North Dakota Department of Transportation

ADDENDUM 1 – JOB 2

TO: All prospective bidders on projects SOIA-7-085(096)192, Job No. 2 scheduled for the May 22, 2014 bid opening.

SRF No. 7594

Revised 5/12/2014	STATE	PROJECT NO.	SECTION NO.	SHEET NO.
	ND	SOIA-7-085(096)192	200	81

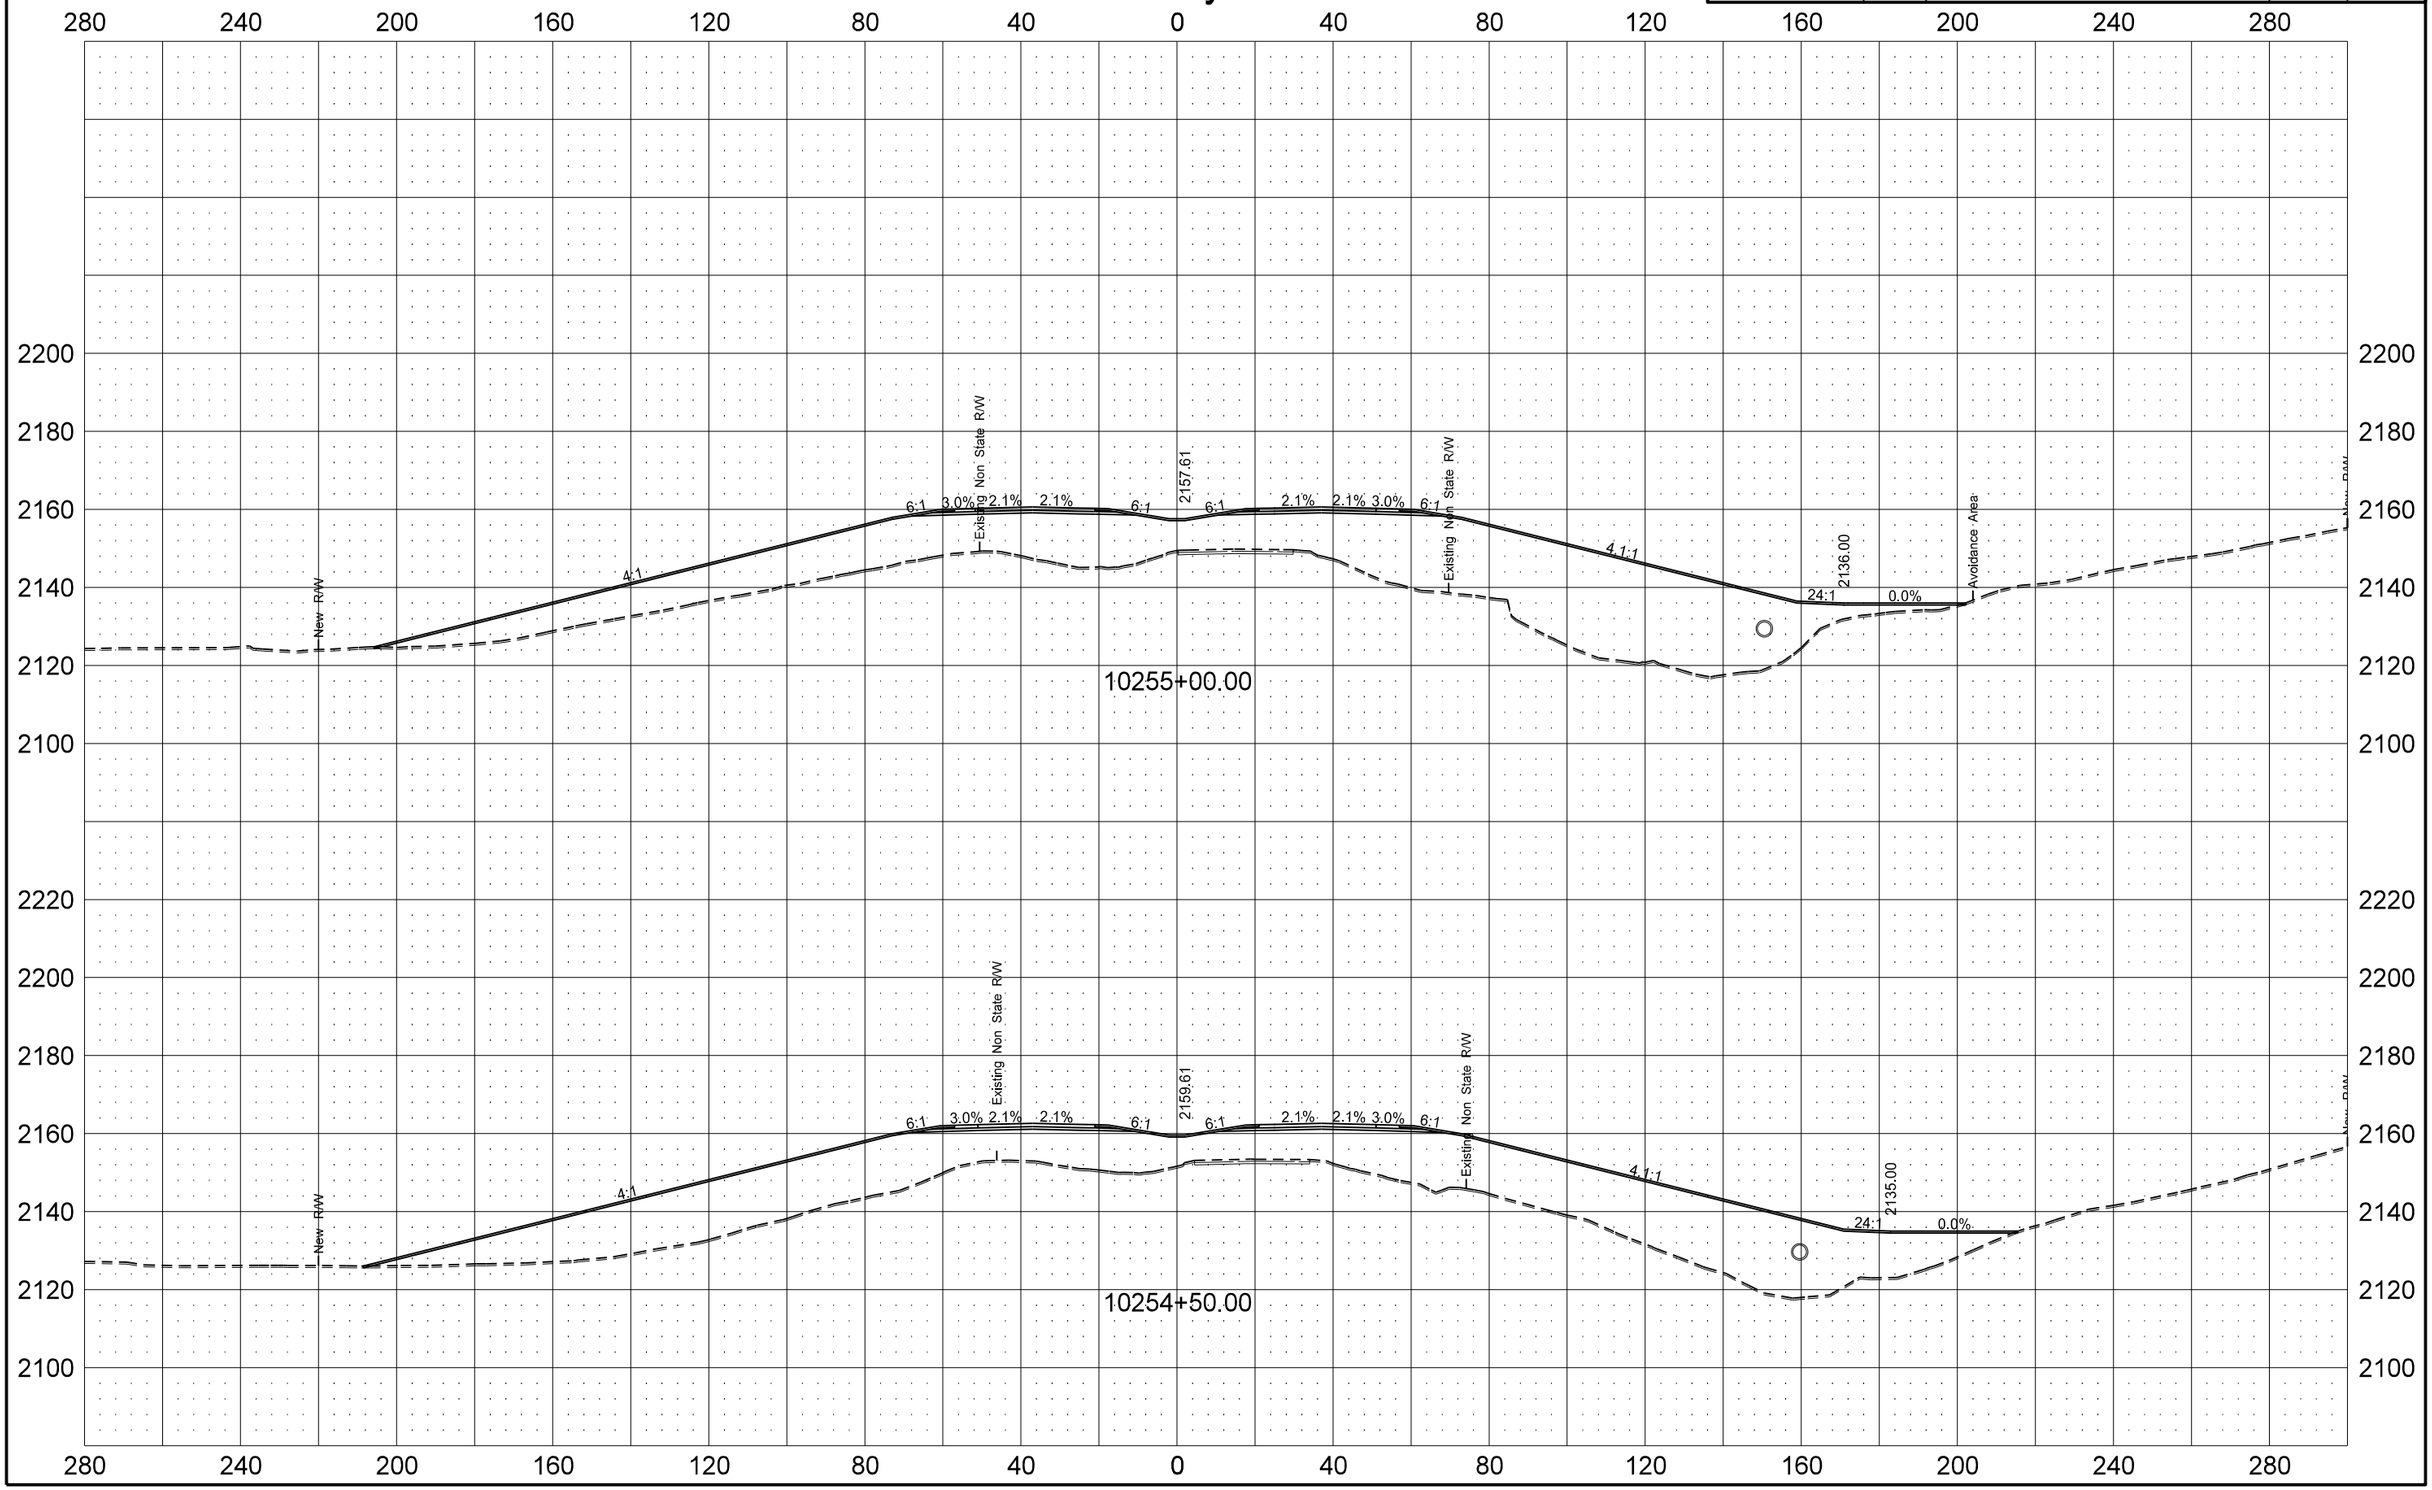
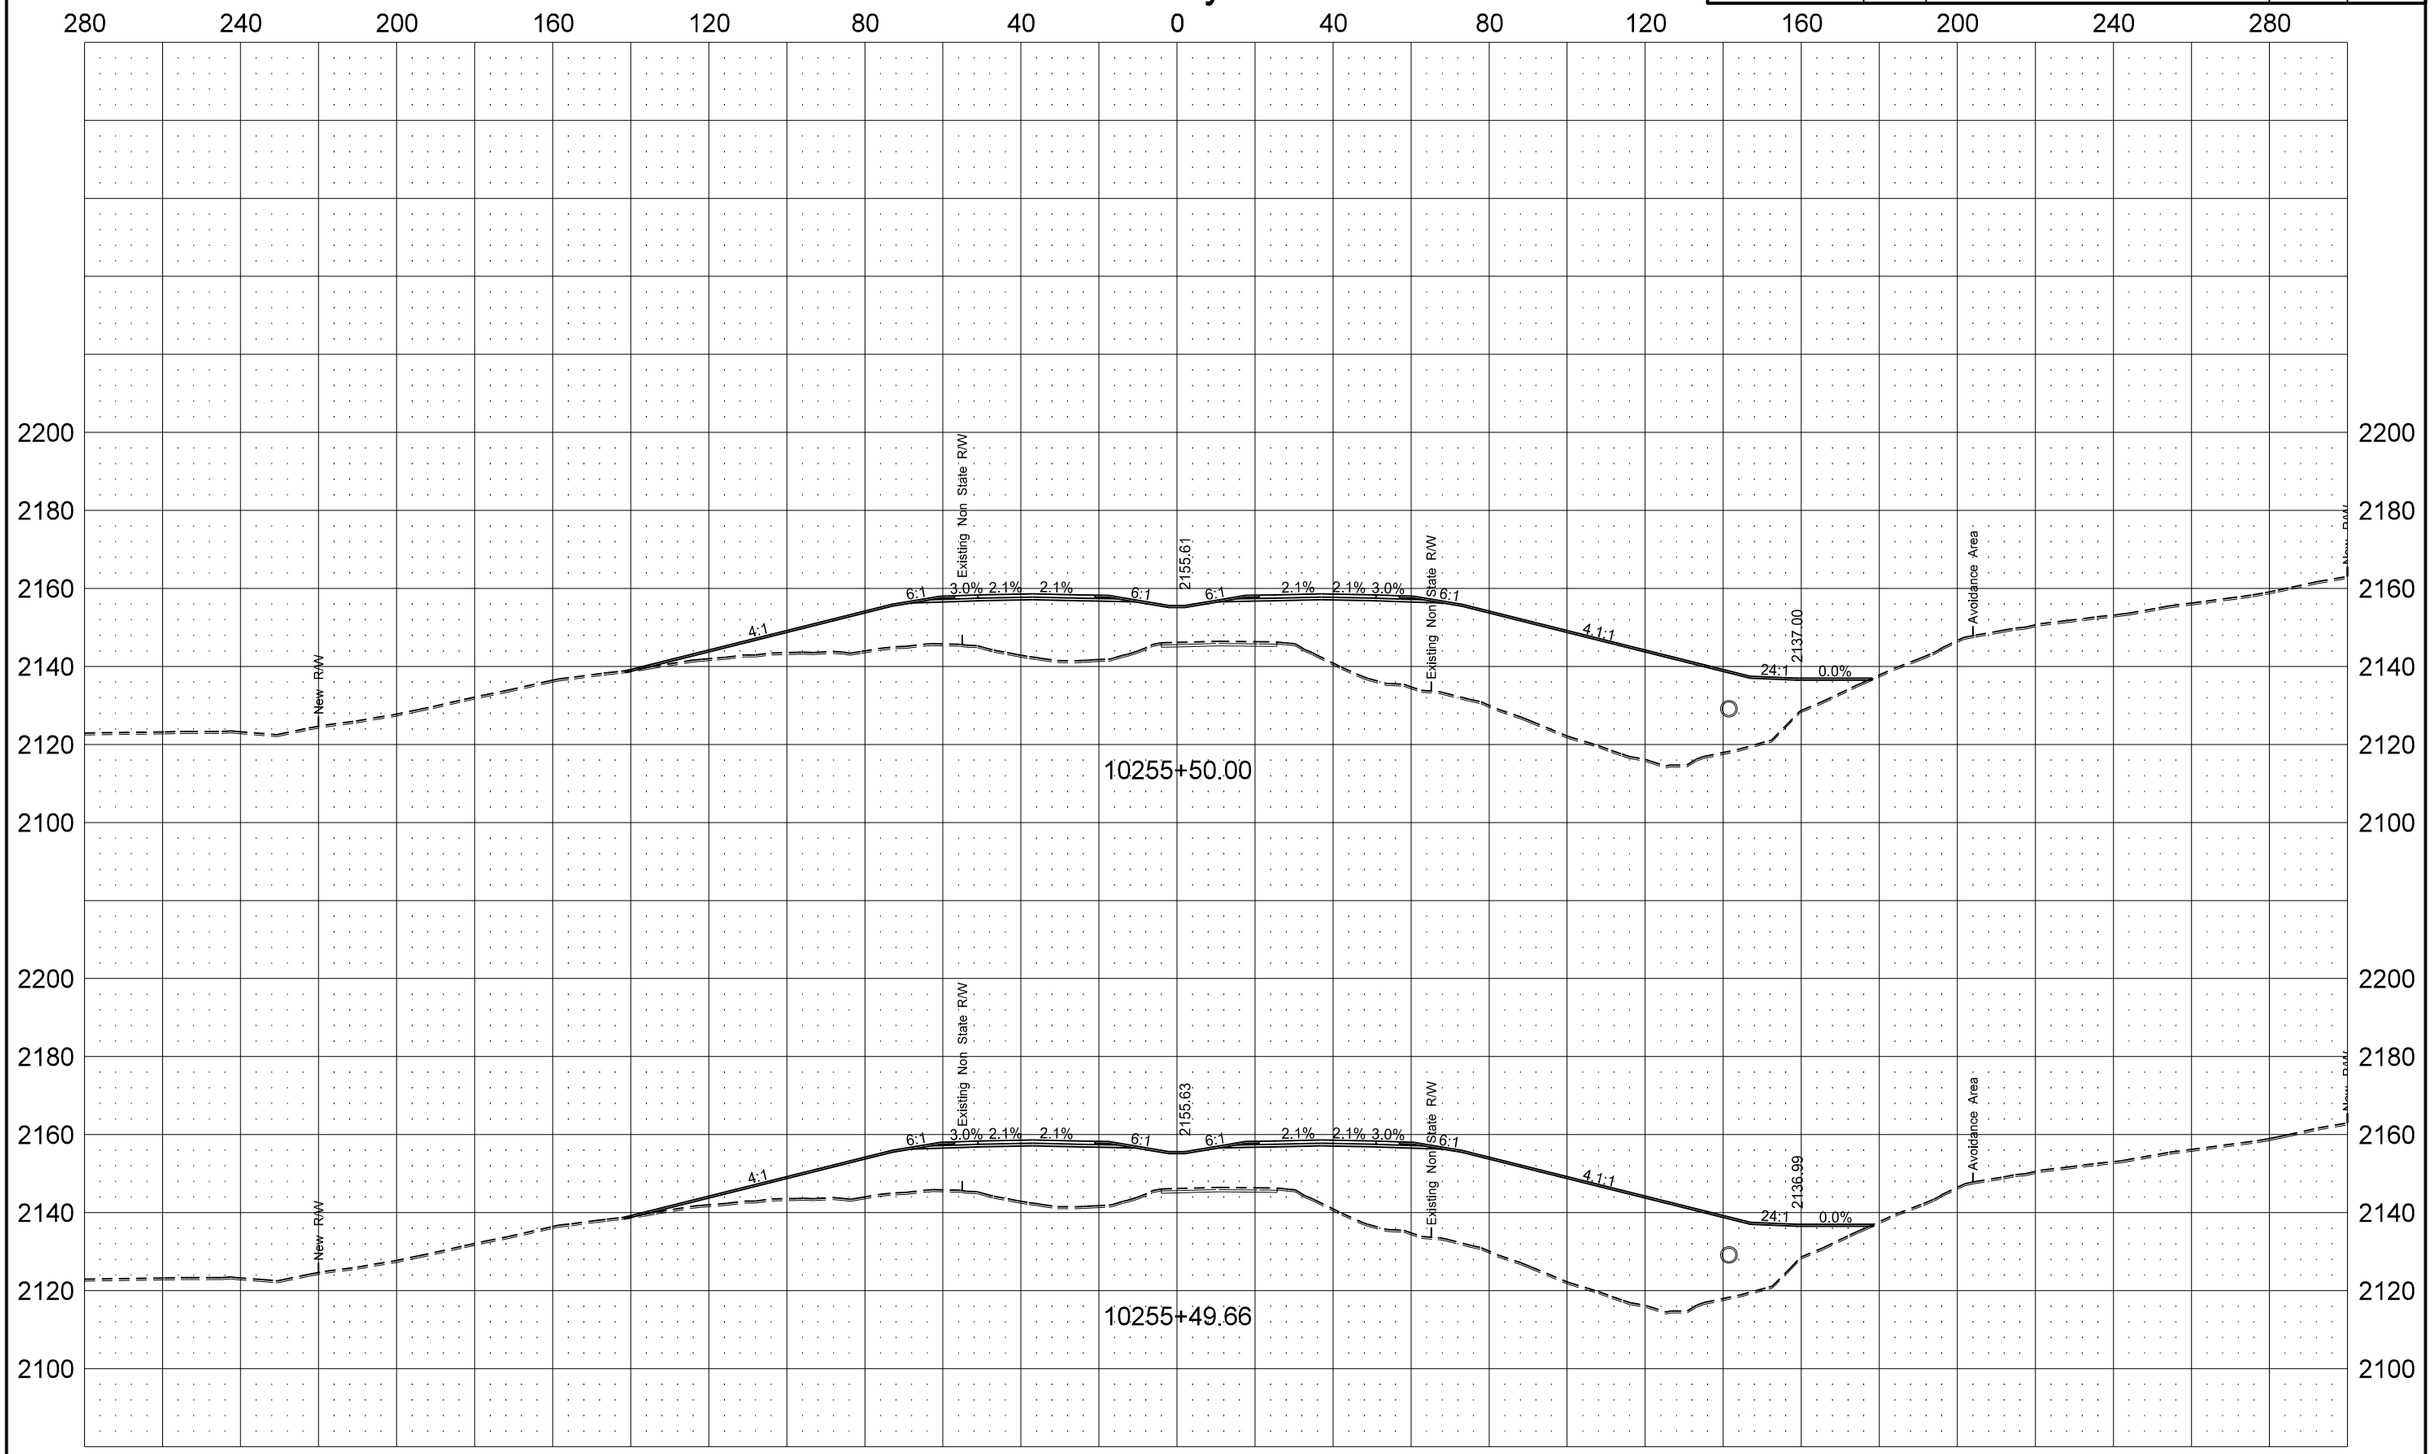
Sheets 200-78 through 200-107:
Revised cross sections due to change in retaining wall.
